**BEFORE THE HEARINGS PANEL
FOR THE QUEENSTOWN LAKES PROPOSED DISTRICT PLAN**

IN THE MATTER of Hearing Stream 14:
Wakatipu Basin
hearing and
transferred Stage 1
submissions related to
Arrowtown and Lake
Hayes

**REPLY OF BRIDGET MARY GILBERT
ON BEHALF OF QUEENSTOWN LAKES DISTRICT COUNCIL**

10 August 2018

----- Approximate location of the Precinct (i.e. 400m contour line)

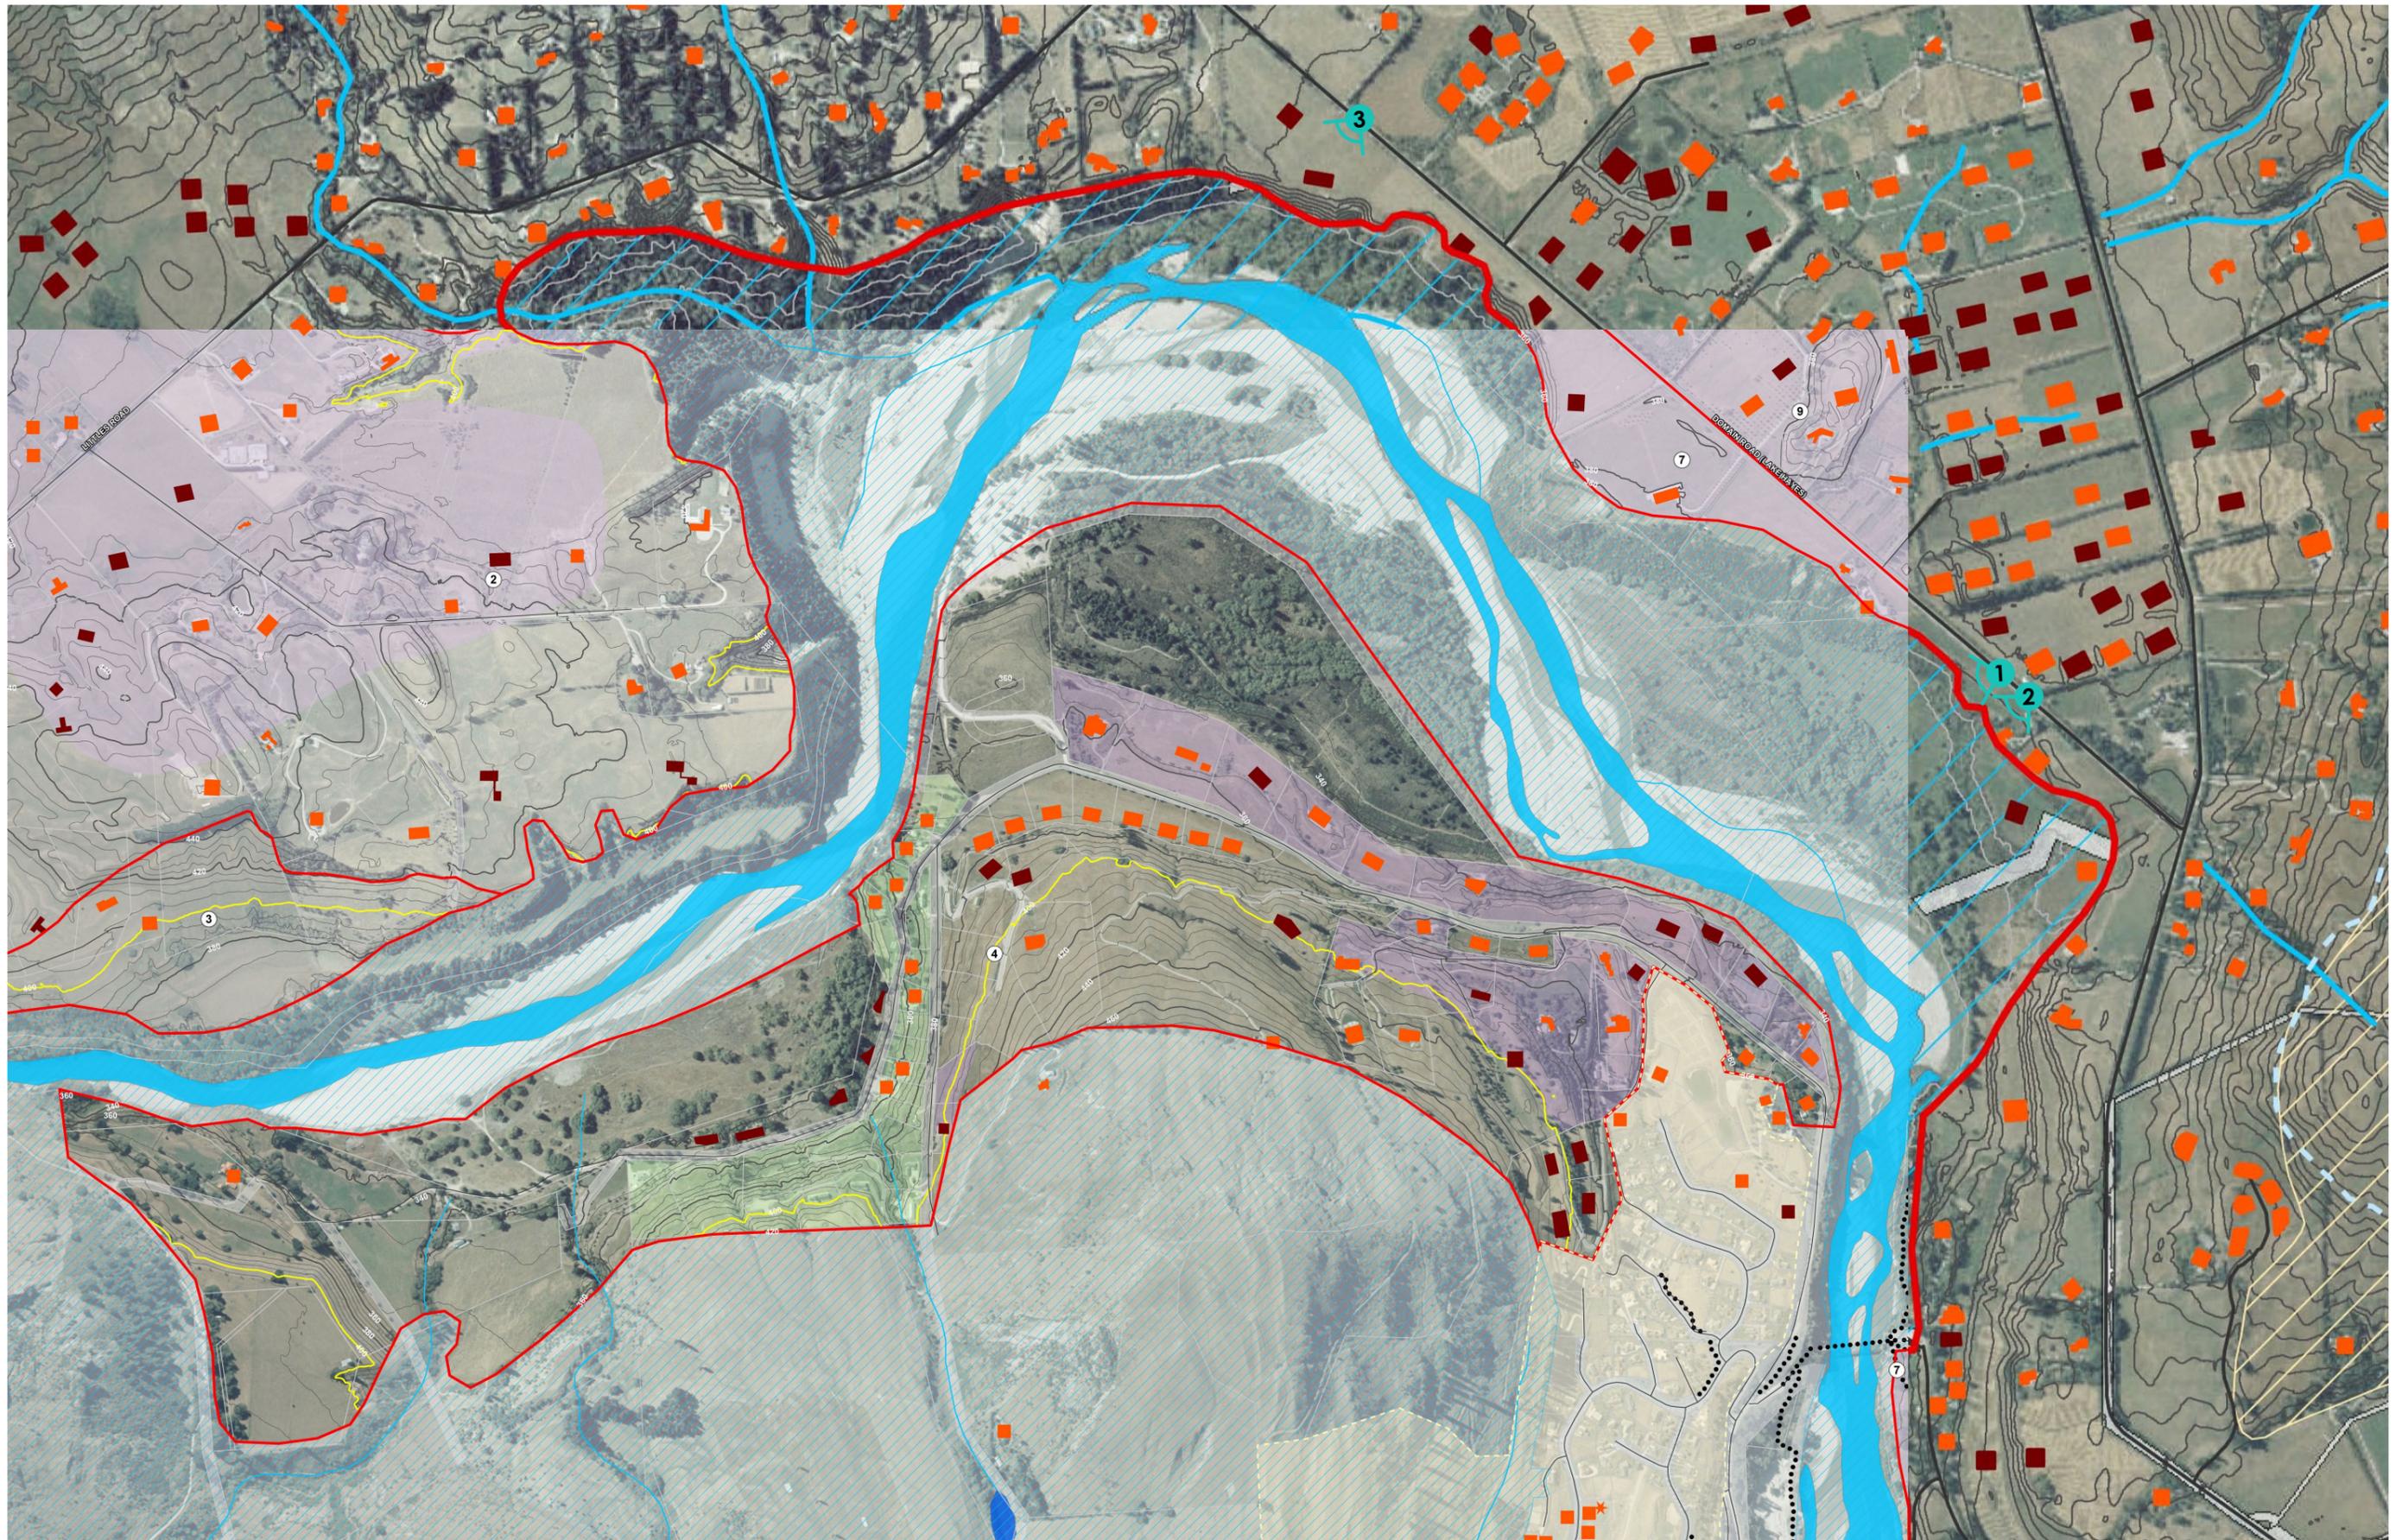
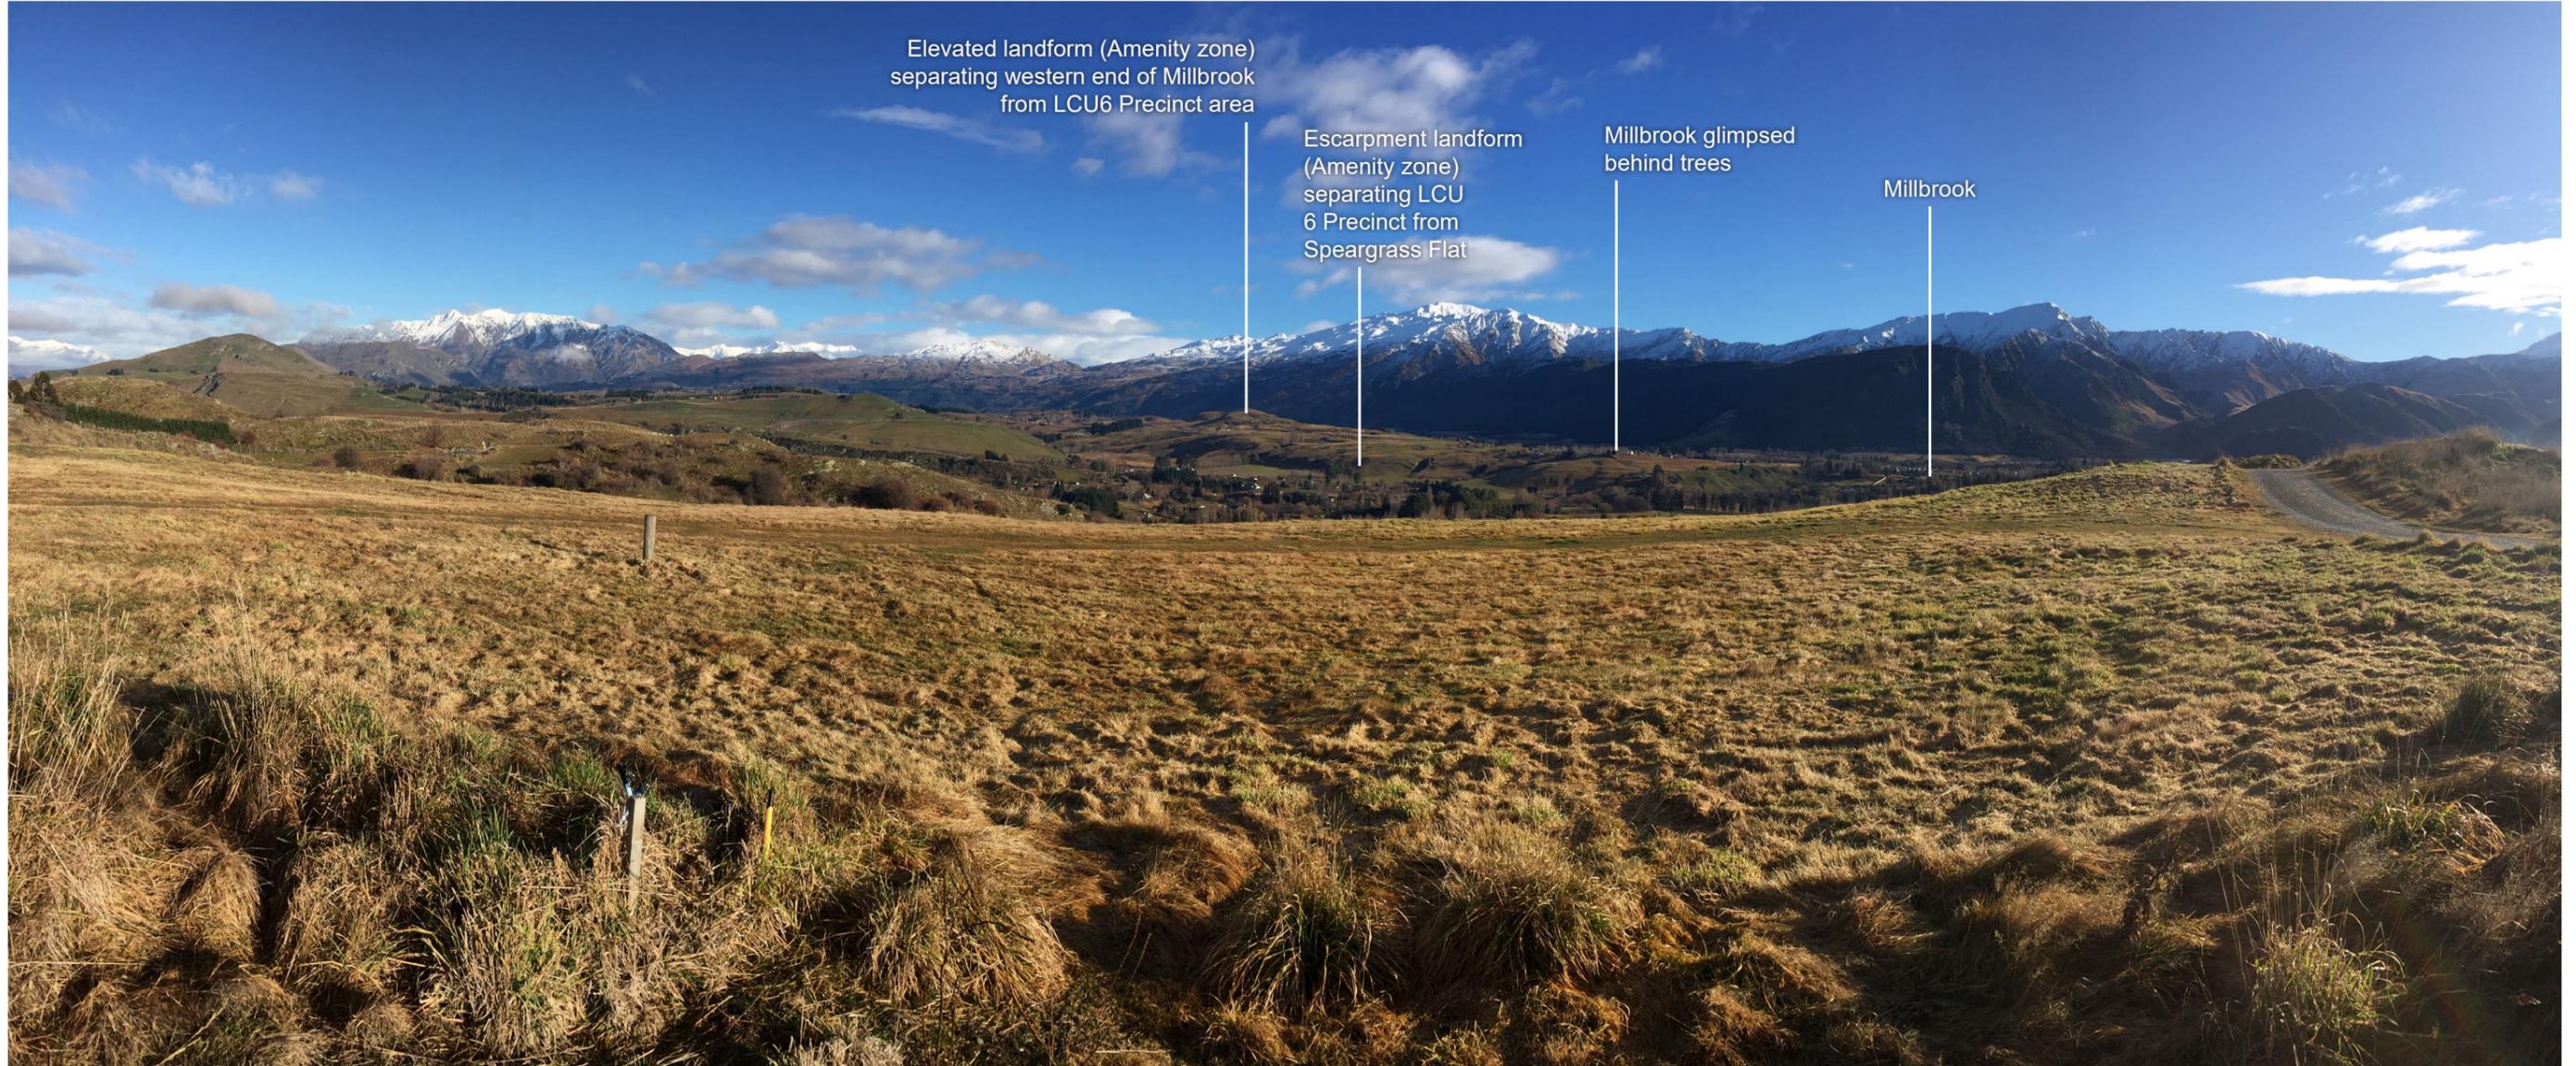
- 5.1** The Panel have requested annotated photographs of LCU 4 Tucker Beach that illustrate the location of my proposed Precinct boundary (i.e. the 400m contour line) 'on the ground'.

- 5.2** The photographs in **Appendix 1** illustrate the approximate location of the Precinct boundary in three views from Domain Road to the Tucker Beach area. **Appendix 1** Sheet 4 shows the location of each photograph.

- 5.4** The photographs demonstrate the intention to confine new rural residential development within this part of the Basin to the low-lying fringe of 'existing development' that flanks Tucker Beach Road (noting that the existing development patterning relied on in my analysis in this regard includes consented and unbuilt platforms).
